Subject: Marks to control the correct mounting of elevator.

Effectivity: Glider aeroplane SPEED ASTIR II and SPEED ASTIR II B starting from serial number 4001

Technische Mitteilung
TM 320-3

SPEED ASTIR II
SPEED ASTIR II B

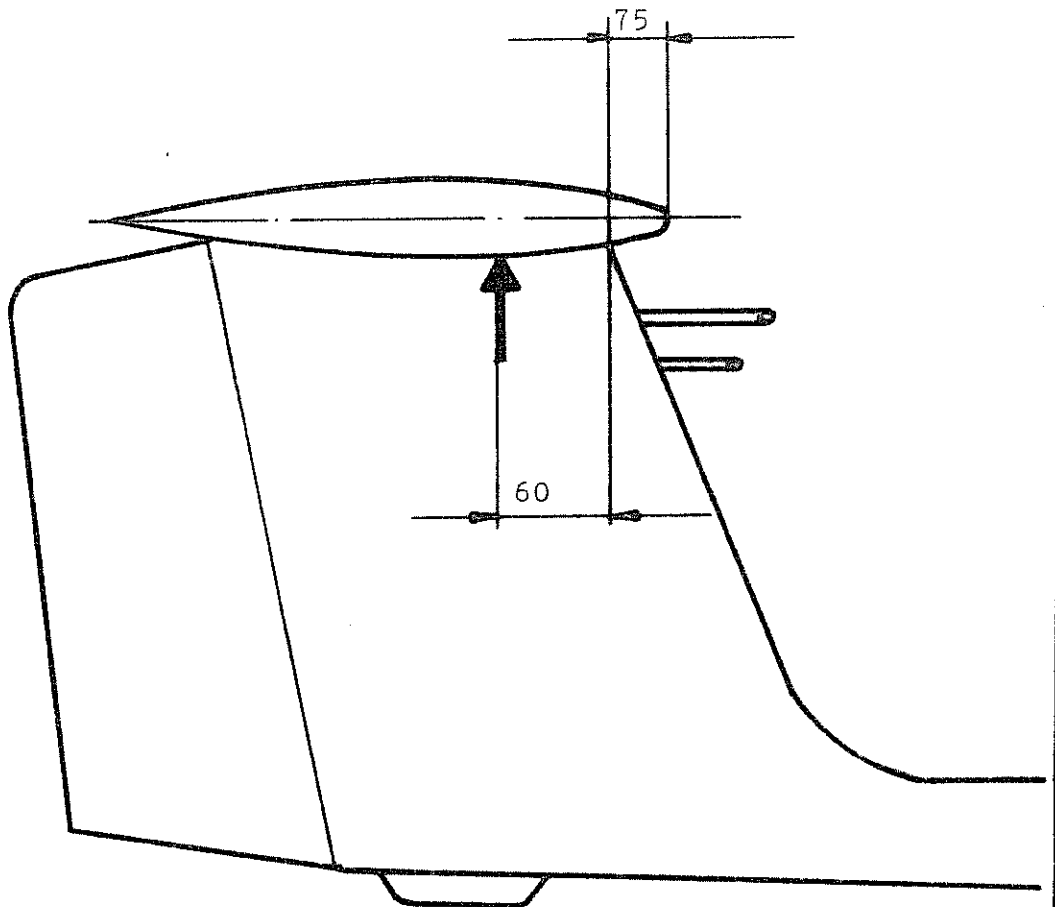
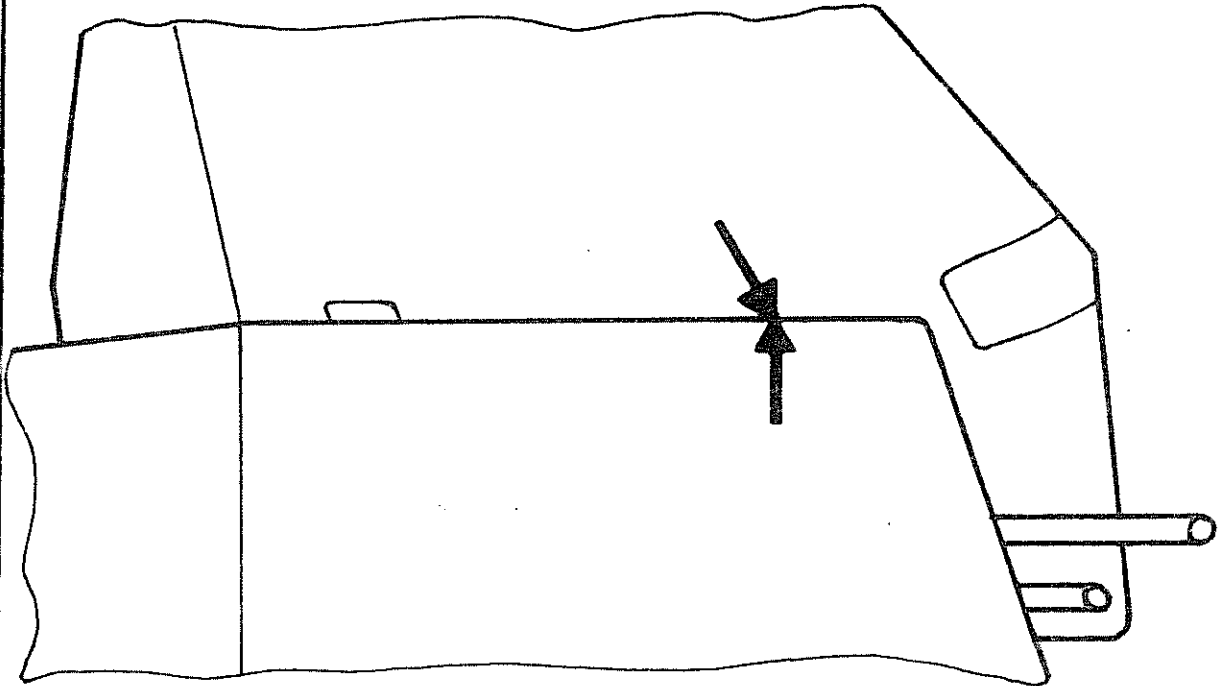
- 1a) Mounting elevator section according to Flight Manual page 23. It is important to ensure, that the larger opening of the conical drillings in the inner rings of the horizontal stabilizer spar bearings fall to the rear.

- 1b) Provided the 4 markings at elevator and fin are still existing they must coincide after correct mounting. The former badly adhevent markings should be removed and replaced by new ones at the same position.

- 1c) Provided the 4 markings at elevator and fin are missing completely or partially, the rest of the previous marks should be removed and replaced by new markings according to construction drawing.

- 1d) To attach the new marks, it is necessary to remove the paper cover before rubbing the arrow firmly with the transparent foil. Then the foil should be carefully removed and the mark again pressed. After 24 hours the adherence is sufficient enough ~~to tape the markings~~. There is no risk to remove the marking inadvertently when removing the tape.

- 2) Reference tabel at fin:
Elevator attached
Wing screw fastened
Elevator secured
must be replaced by the reference tabel:
Elevator attached
Markings notice
Wing screw fastened
Elevator secured
